# RETREAT AT TIMBERRIDGE FILING NO. 2

# CONSTRUCTION DRAWINGS

Engineering Review  
12/10/2021 1:20:54 PM  
dsdrice  
JeffRice@elpasoco.com  
(719) 520-7877  
EPC Planning & Community  
Development Department

RETREAT AT TIMBERRIDGE FILING NO. 2  
 CONSTRUCTION PLANS  
 GRADING & EROSION CONTROL PLAN  
 DESIGNED BY PRA SCALE DATE 02-25-21  
 DRAWN BY PRA (H) 1" = 100' SHEET 3 OF 24  
 CHECKED BY (V) 1" = N/A JOB NO. 1185.20

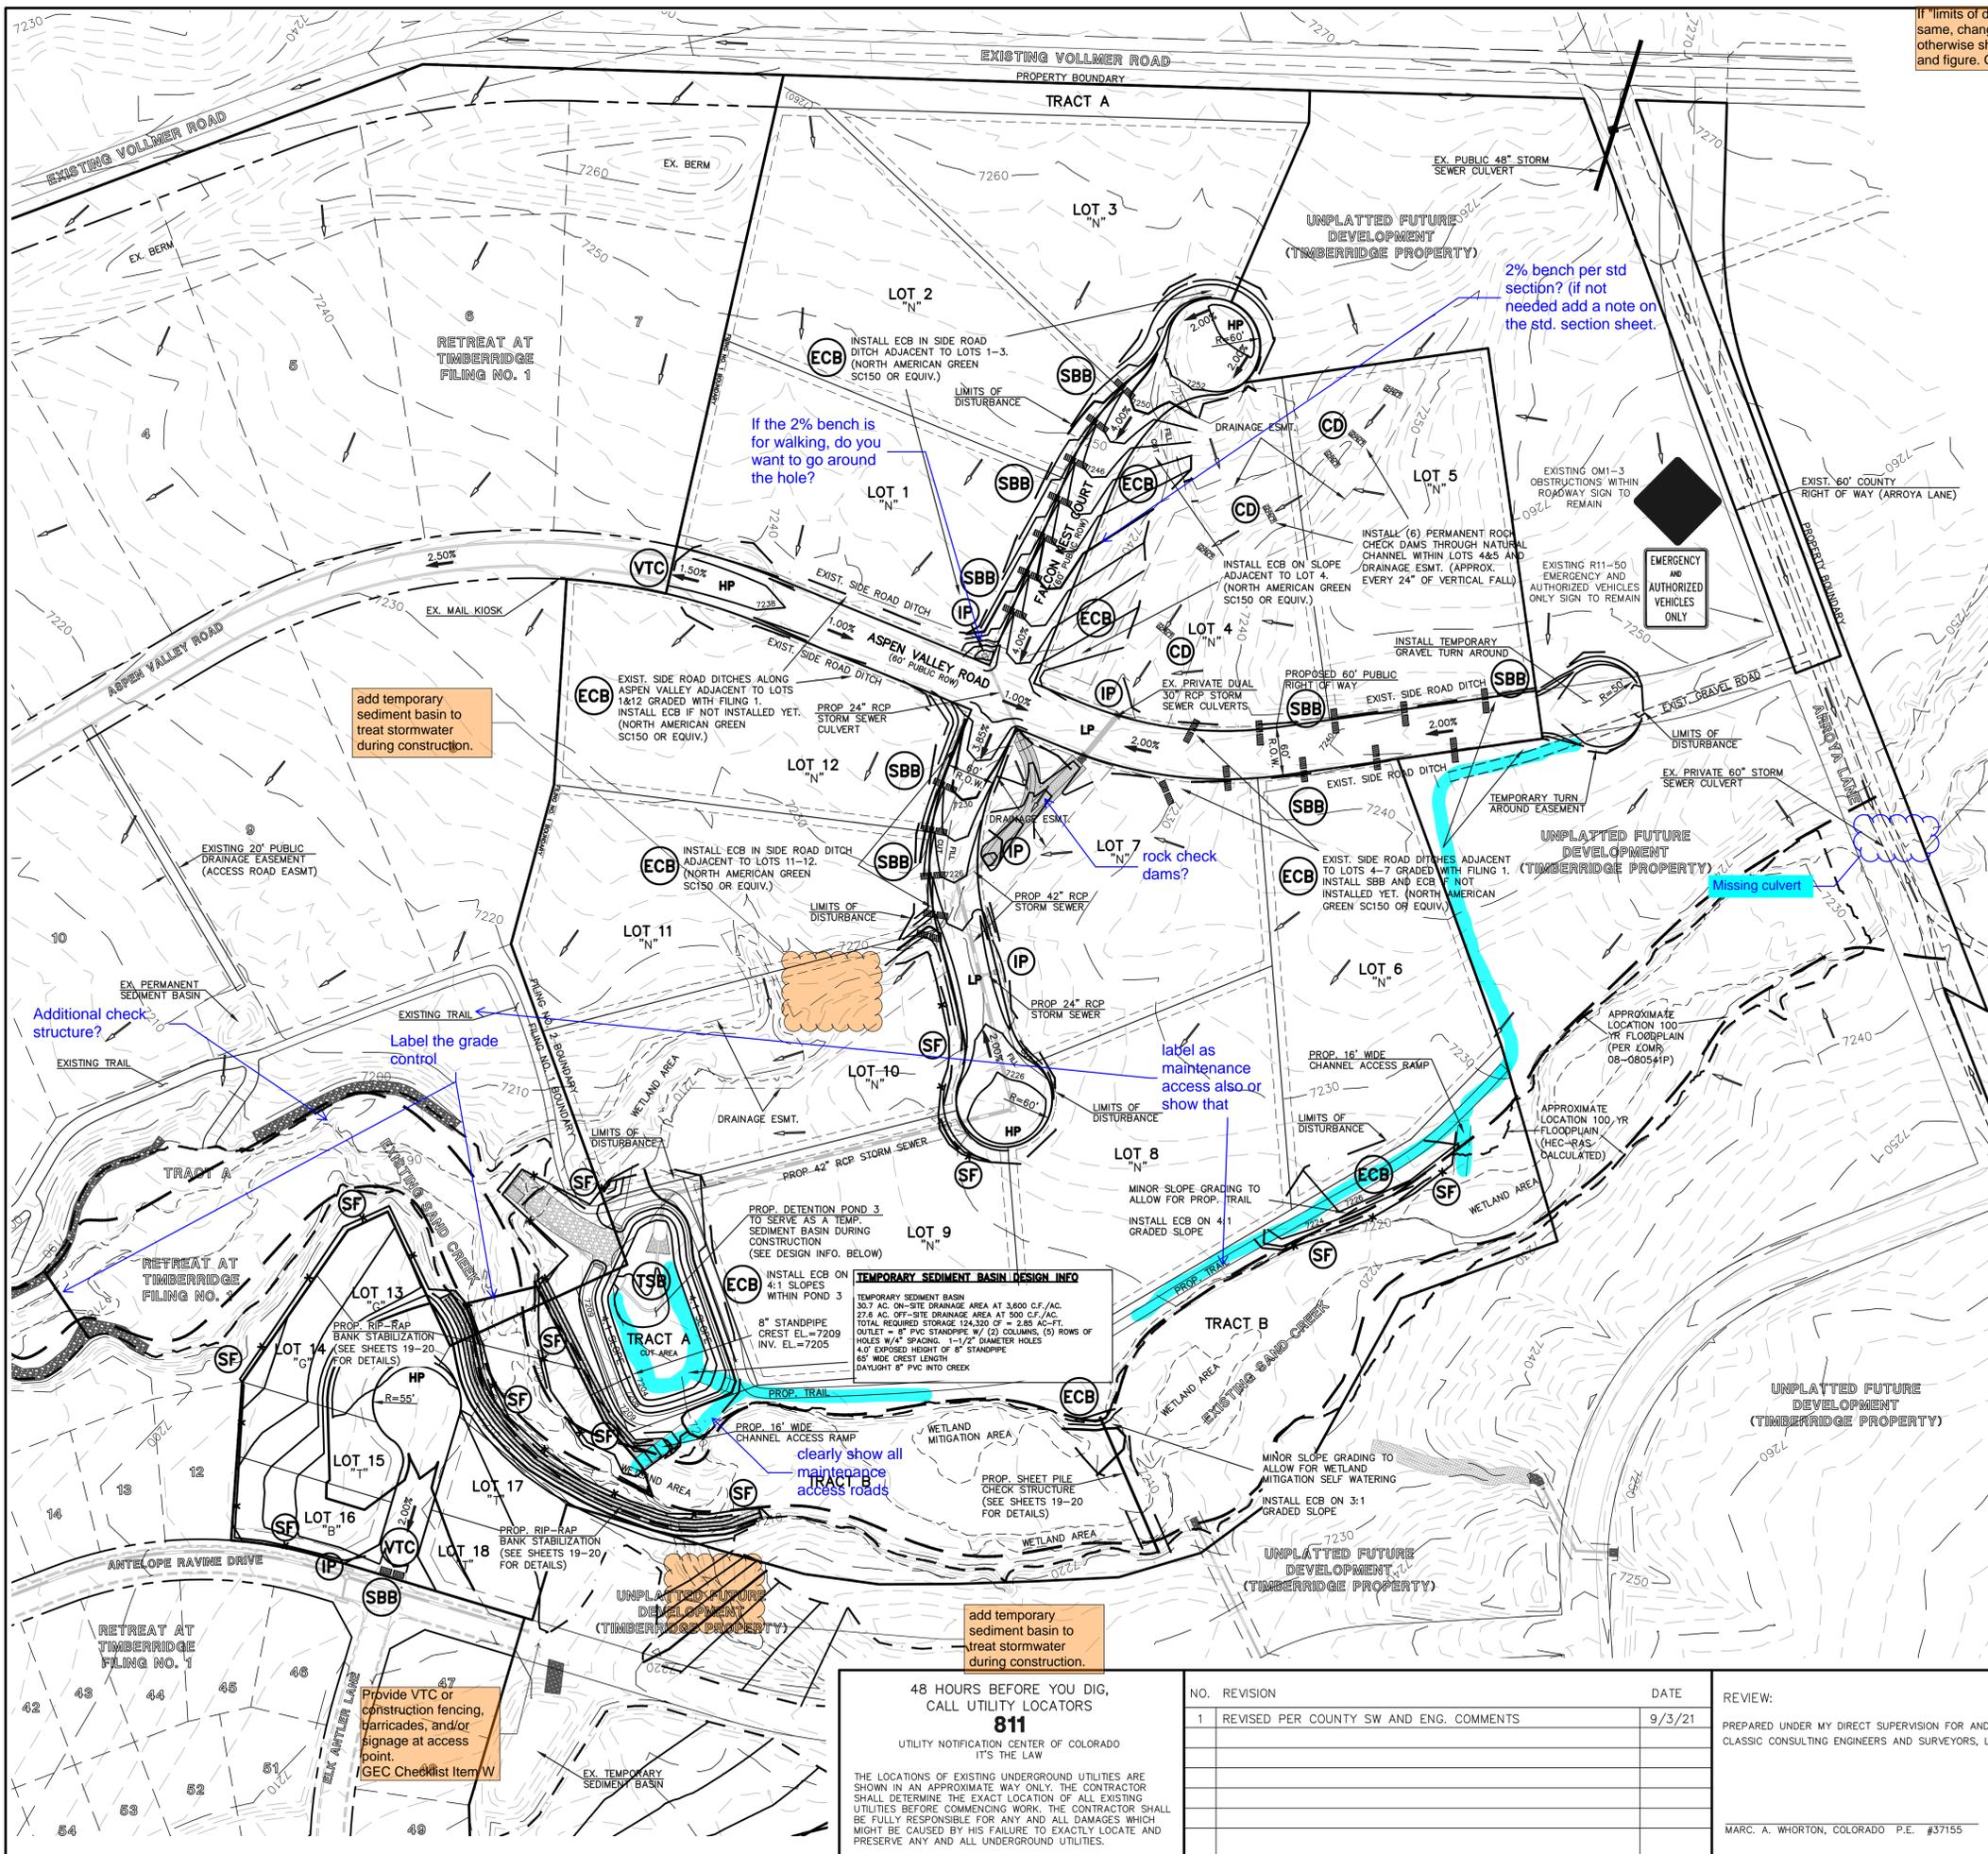
If "limits of disturbance" and "construction boundary" are the same, change to "limits of construction/disturbance" or otherwise show as separate line types for each on the legend and figure. GEC Checklist Item H

| <p>48 HOURS BEFORE YOU DIG, CALL UTILITY LOCATORS</p> <p><b>811</b></p> <p>UTILITY NOTIFICATION CENTER OF COLORADO<br/>IT'S THE LAW</p> <p>THE LOCATIONS OF EXISTING UNDERGROUND UTILITIES ARE SHOWN IN AN APPROXIMATE WAY ONLY. THE CONTRACTOR SHALL DETERMINE THE EXACT LOCATION OF ALL EXISTING UTILITIES BEFORE COMMENCING WORK. THE CONTRACTOR SHALL BE FULLY RESPONSIBLE FOR ANY AND ALL DAMAGES WHICH MIGHT BE CAUSED BY HIS FAILURE TO EXACTLY LOCATE AND PRESERVE ANY AND ALL UNDERGROUND UTILITIES.</p> | <table border="1" style="width: 100%; border-collapse: collapse;"> <thead> <tr> <th>NO.</th> <th>REVISION</th> <th>DATE</th> </tr> </thead> <tbody> <tr> <td>1</td> <td>REVISED PER COUNTY SW AND ENG. COMMENTS</td> <td>9/2/21</td> </tr> </tbody> </table> | NO.          | REVISION | DATE     | 1 | REVISED PER COUNTY SW AND ENG. COMMENTS | 9/2/21 | <p>REVIEW:</p> <p>PREPARED UNDER MY DIRECT SUPERVISION FOR AND ON BEHALF OF CLASSIC CONSULTING ENGINEERS AND SURVEYORS, LLC</p> <p>MARC. A. WHORTON, COLORADO P.E. #37155      DATE</p> | <p><b>CLASSIC CONSULTING</b></p> | <p>RETREAT AT TIMBERIDGE FILING NO. 2</p> <p>CONSTRUCTION PLANS</p> <p>GRADING &amp; EROSION CONTROL PLAN</p> <table border="1" style="width: 100%; border-collapse: collapse;"> <tr> <td>DESIGNED BY</td> <td>PRA</td> <td>SCALE</td> <td>DATE</td> <td>02-25-21</td> </tr> <tr> <td>DRAWN BY</td> <td>PRA</td> <td>(H) 1" = 60'</td> <td>SHEET</td> <td>4 OF 24</td> </tr> <tr> <td>CHECKED BY</td> <td>(V) 1" = N/A</td> <td>JOB NO.</td> <td colspan="2">1185.20</td> </tr> </table> | DESIGNED BY | PRA | SCALE | DATE | 02-25-21 | DRAWN BY | PRA | (H) 1" = 60' | SHEET | 4 OF 24 | CHECKED BY | (V) 1" = N/A | JOB NO. | 1185.20 |  |
|---|--|--------------|----------|----------|---|---|--------|---|----------------------------------|--|-------------|-----|-------|------|----------|----------|-----|--------------|-------|---------|------------|--------------|---------|---------|--|
| DRAWN BY  | PRA  | (H) 1" = 60' | SHEET    | 4 OF 24  |   |   |        |   |                                  |  |             |     |       |      |          |          |     |              |       |         |            |              |         |         |  |

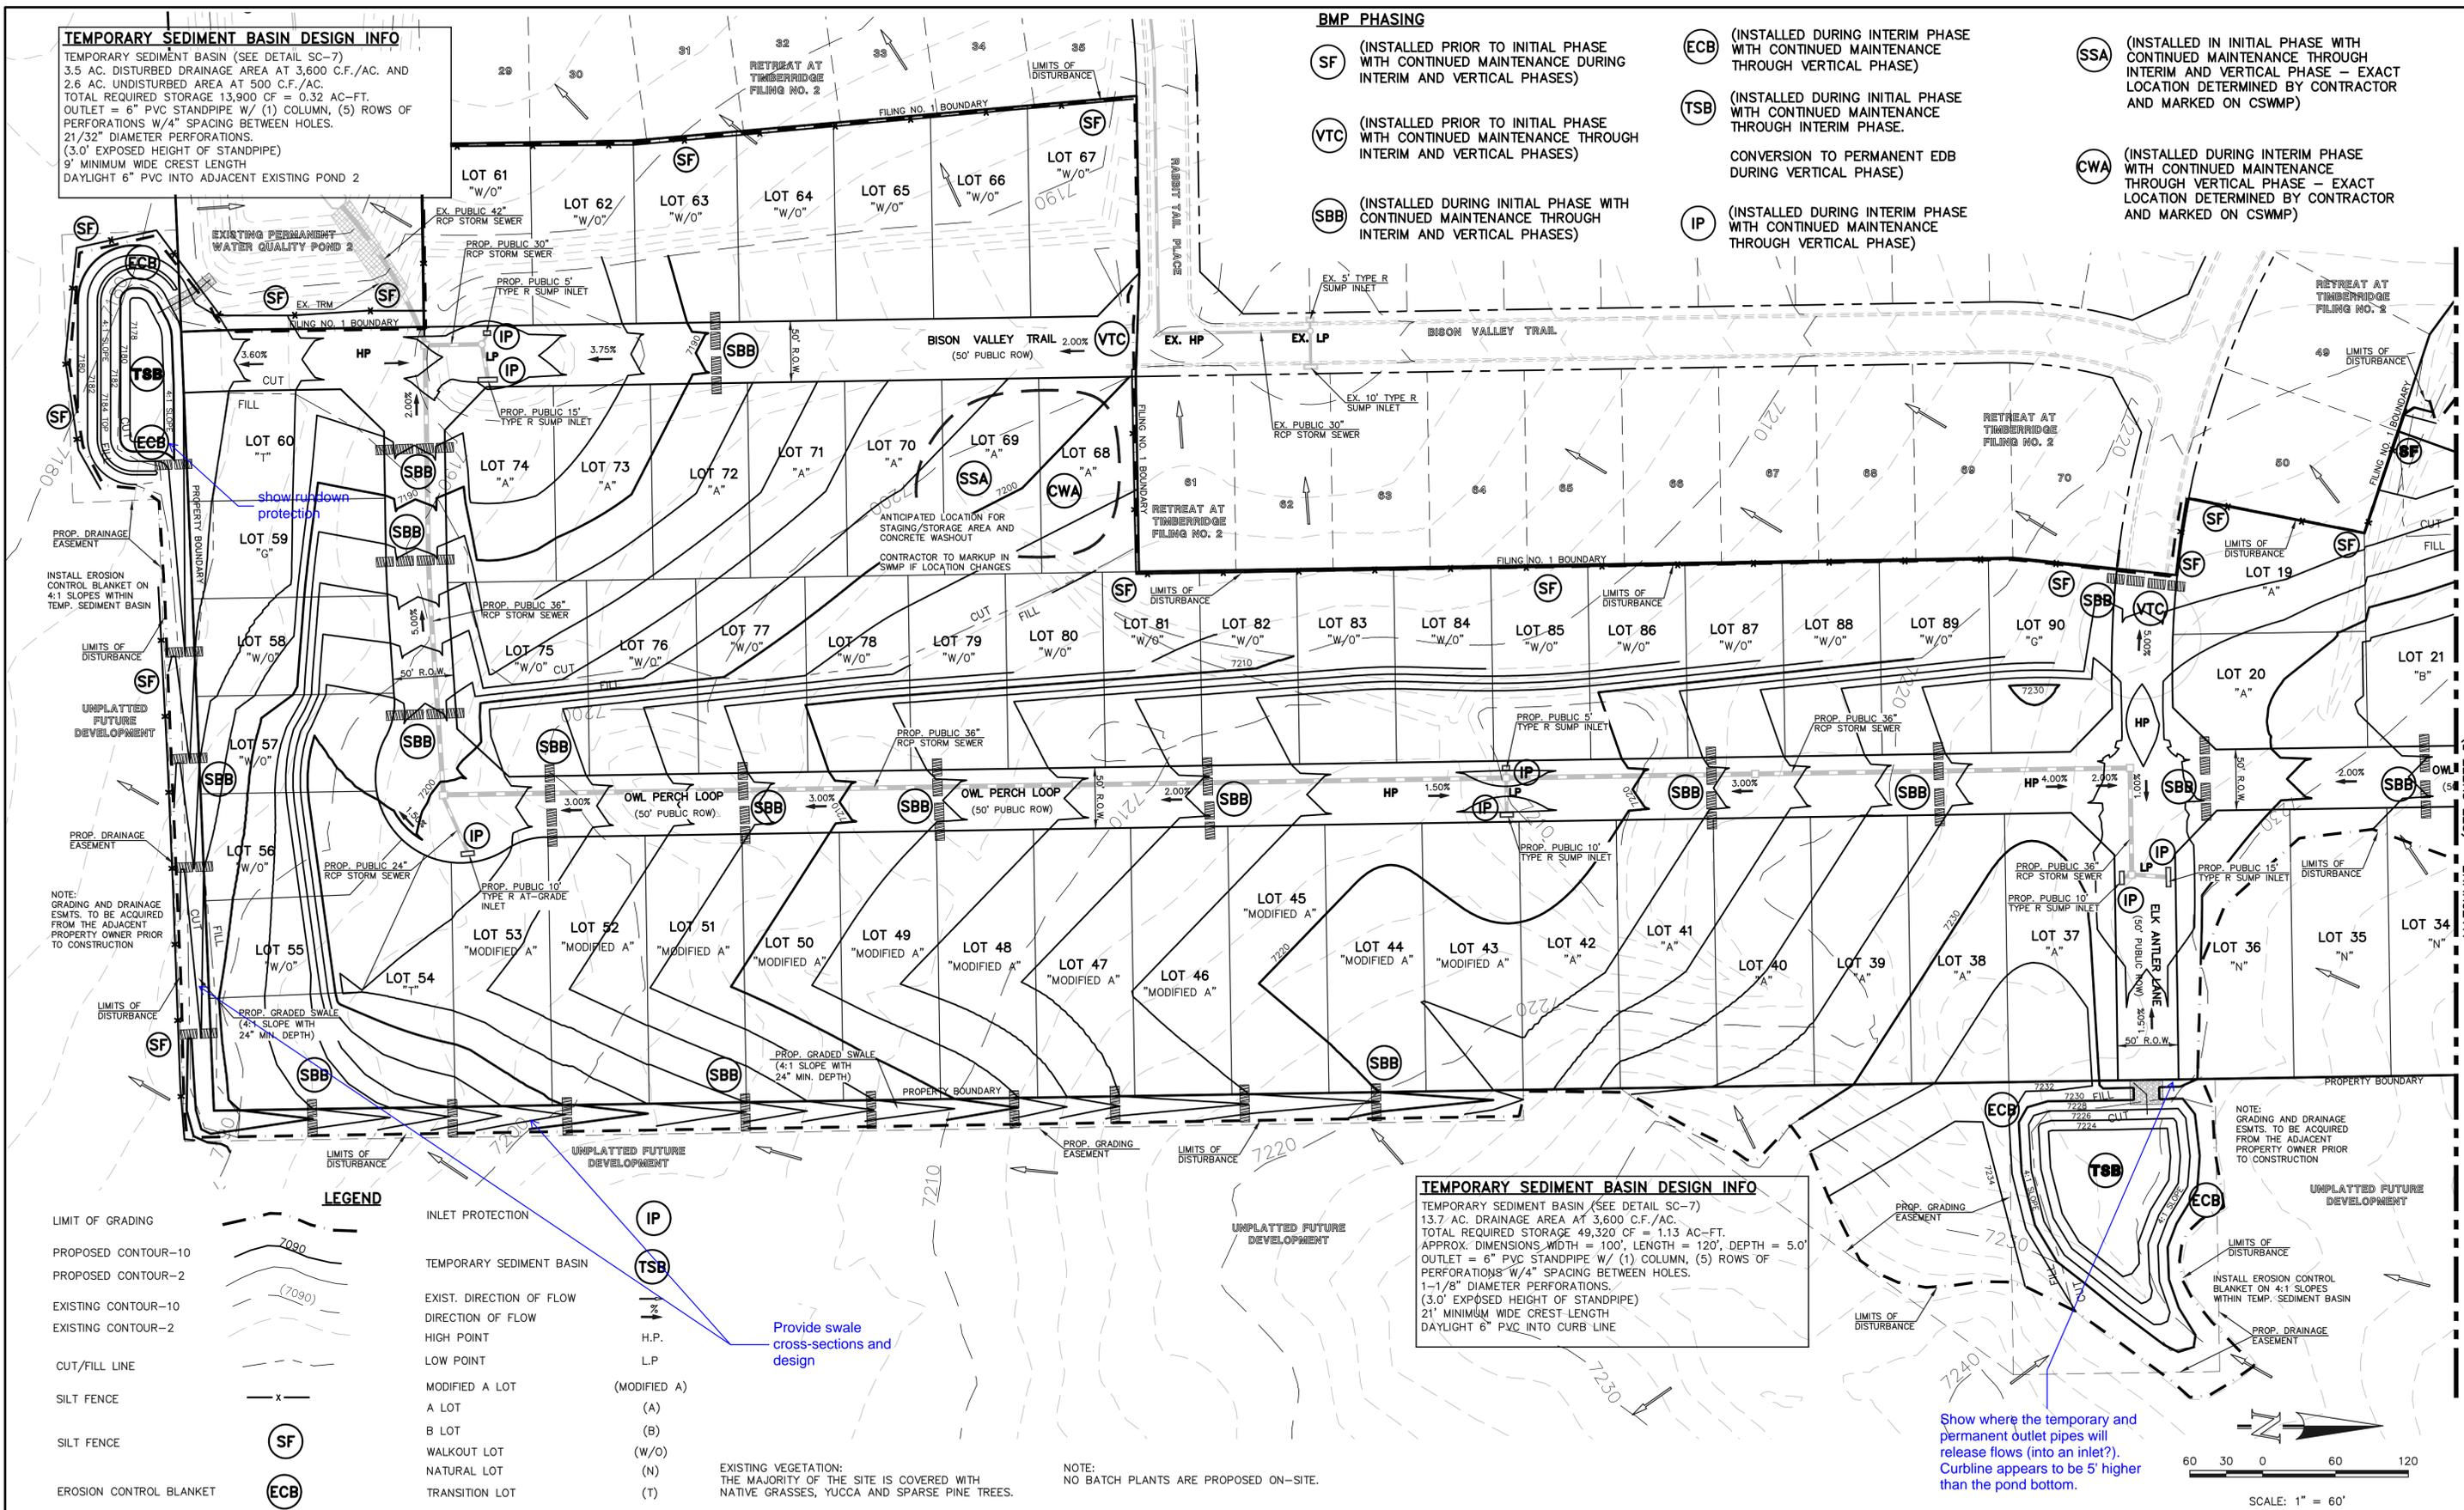
Show where the temporary and permanent outlet pipes will release flows (into an inlet?). Curbs appear to be 5' higher than the pond bottom.

| <p>48 HOURS BEFORE YOU DIG,<br/>CALL UTILITY LOCATORS<br/><b>811</b><br/>UTILITY NOTIFICATION CENTER OF COLORADO<br/>IT'S THE LAW</p> <p>THE LOCATIONS OF EXISTING UNDERGROUND UTILITIES ARE SHOWN IN AN APPROXIMATE WAY ONLY. THE CONTRACTOR SHALL DETERMINE THE EXACT LOCATION OF ALL EXISTING UTILITIES BEFORE COMMENCING WORK. THE CONTRACTOR SHALL BE FULLY RESPONSIBLE FOR ANY AND ALL DAMAGES WHICH MIGHT BE CAUSED BY HIS FAILURE TO EXACTLY LOCATE AND PRESERVE ANY AND ALL UNDERGROUND UTILITIES.</p> | <table border="1" style="width: 100%; border-collapse: collapse;"> <thead> <tr> <th>NO.</th> <th>REVISION</th> <th>DATE</th> </tr> </thead> <tbody> <tr> <td>1</td> <td>REVISED PER COUNTY SW AND ENG. COMMENTS</td> <td>9/3/21</td> </tr> <tr> <td> </td> <td> </td> <td> </td> </tr> <tr> <td> </td> <td> </td> <td> </td> </tr> <tr> <td> </td> <td> </td> <td> </td> </tr> </tbody> </table> | NO.          | REVISION | DATE     | 1 | REVISED PER COUNTY SW AND ENG. COMMENTS | 9/3/21 |  |  |  |  |  |  |  |  |  | <p>REVIEW:</p> <p>PREPARED UNDER MY DIRECT SUPERVISION FOR AND ON BEHALF OF CLASSIC CONSULTING ENGINEERS AND SURVEYORS, LLC</p> <p>MARC A. WHORTON, COLORADO P.E. #37155      DATE</p> | <p><b>CLASSIC CONSULTING</b><br/>SM</p> <p>619 N. Cascade Avenue, Suite 200<br/>Colorado Springs, Colorado 80903<br/>(719) 785-0790<br/>(719) 785-0799 (Fax)</p> | <p><b>RETREAT AT TIMBERRIDGE FILING NO. 2</b><br/><b>CONSTRUCTION PLANS</b><br/>GRADING &amp; EROSION CONTROL PLAN</p> <table border="1" style="width: 100%; border-collapse: collapse;"> <tr> <td>DESIGNED BY</td> <td>PRA</td> <td>SCALE</td> <td>DATE</td> <td>02-25-21</td> </tr> <tr> <td>DRAWN BY</td> <td>PRA</td> <td>(H) 1" = 60'</td> <td>SHEET</td> <td>5 OF 24</td> </tr> <tr> <td>CHECKED BY</td> <td>(V)</td> <td>1" = N/A</td> <td>JOB NO.</td> <td>1185.20</td> </tr> </table> | DESIGNED BY | PRA | SCALE | DATE | 02-25-21 | DRAWN BY | PRA | (H) 1" = 60' | SHEET | 5 OF 24 | CHECKED BY | (V) | 1" = N/A | JOB NO. | 1185.20 |
|---|--|--------------|----------|----------|---|---|--------|--|--|--|--|--|--|--|--|--|--|--|--|-------------|-----|-------|------|----------|----------|-----|--------------|-------|---------|------------|-----|----------|---------|---------|
| DRAWN BY  | PRA  | (H) 1" = 60' | SHEET    | 5 OF 24  |   |   |        |  |  |  |  |  |  |  |  |  |  |  |  |             |     |       |      |          |          |     |              |       |         |            |     |          |         |         |

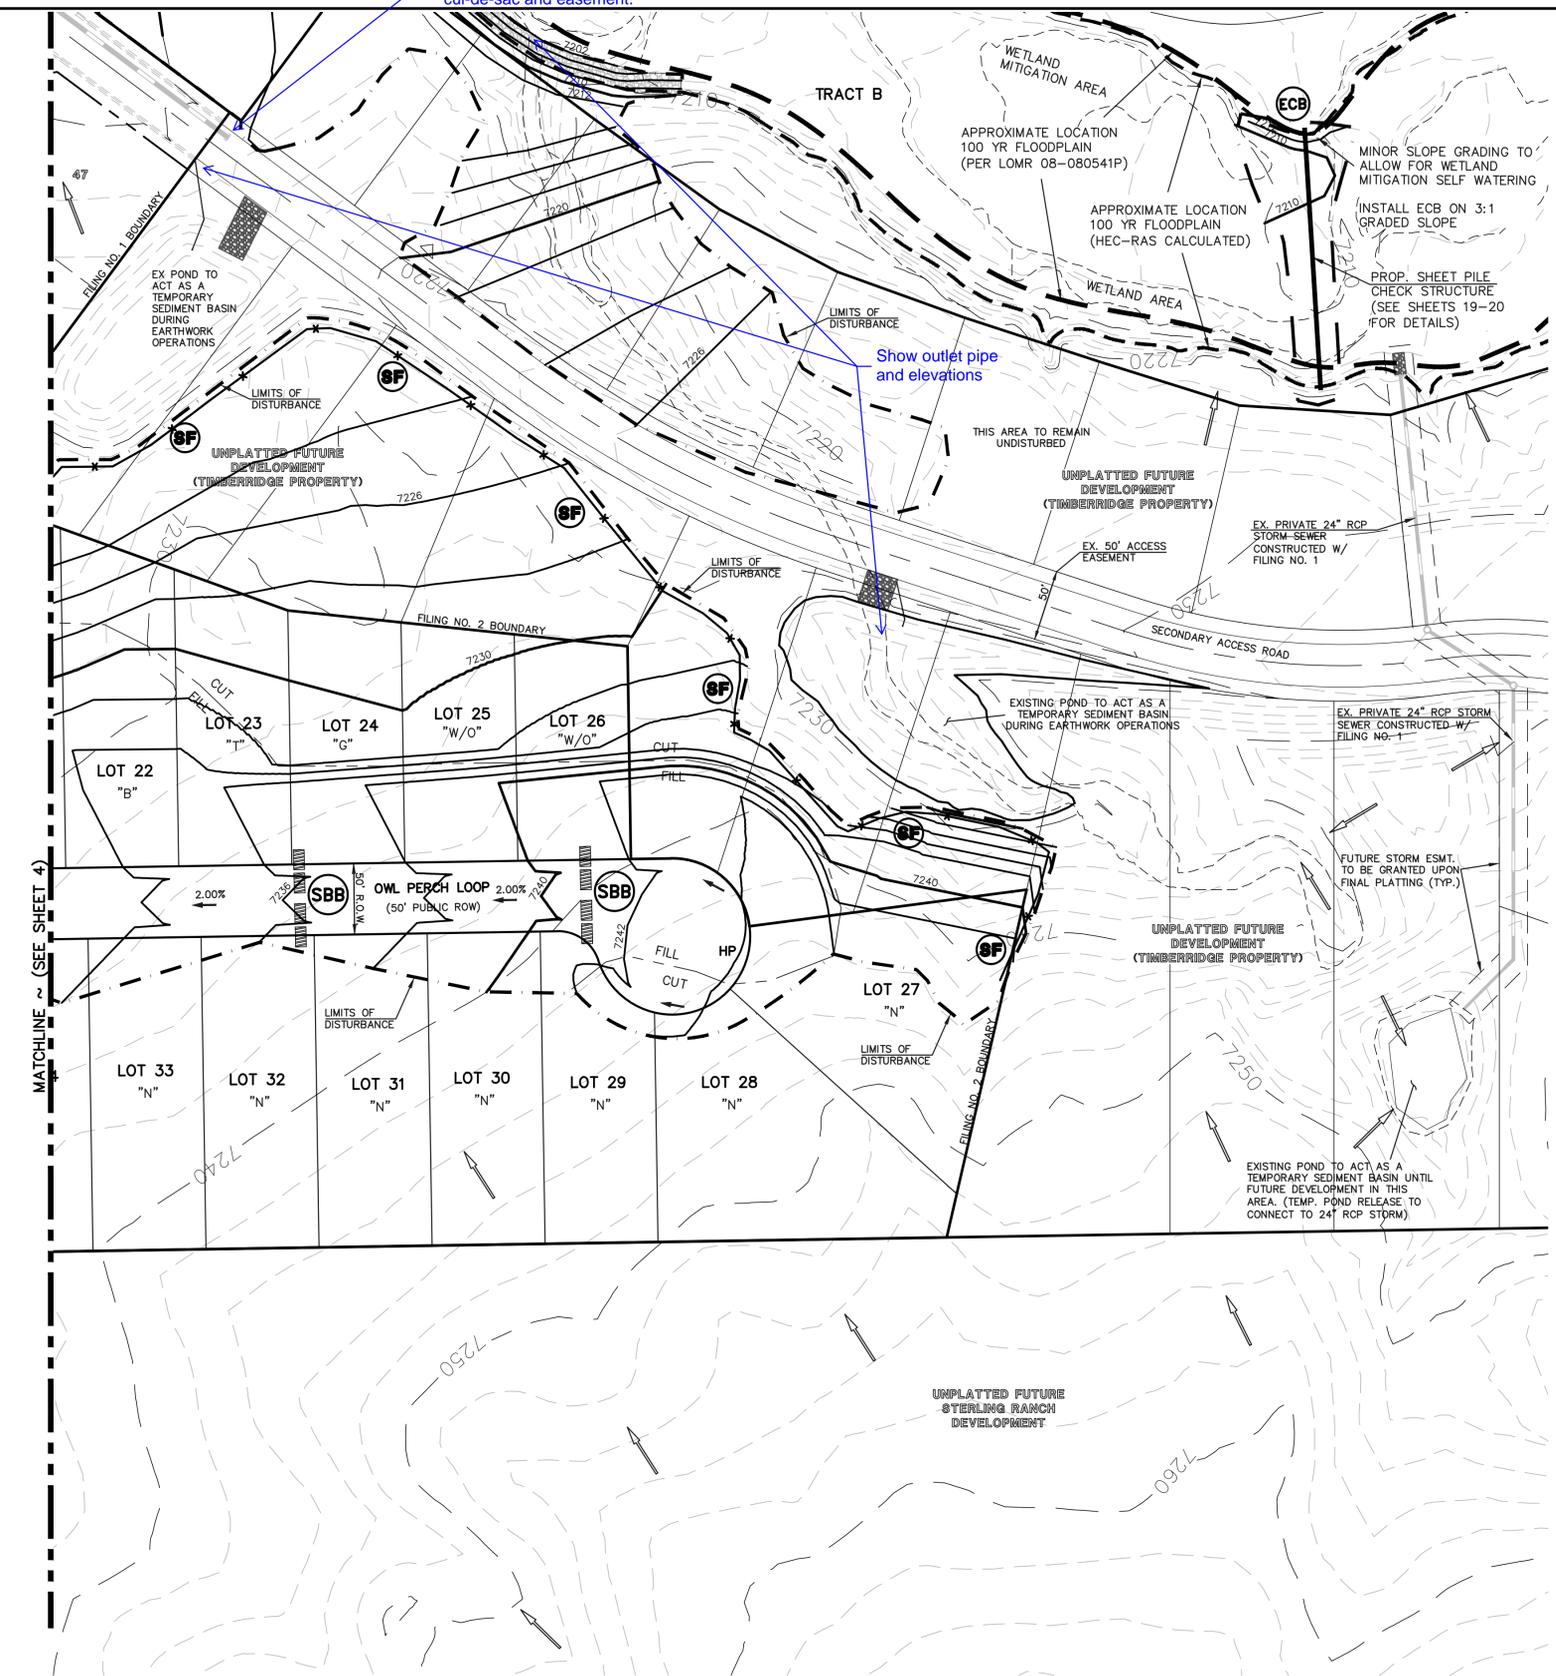
Show the temporary cul-de-sac and easement.

Show outlet pipe and elevations
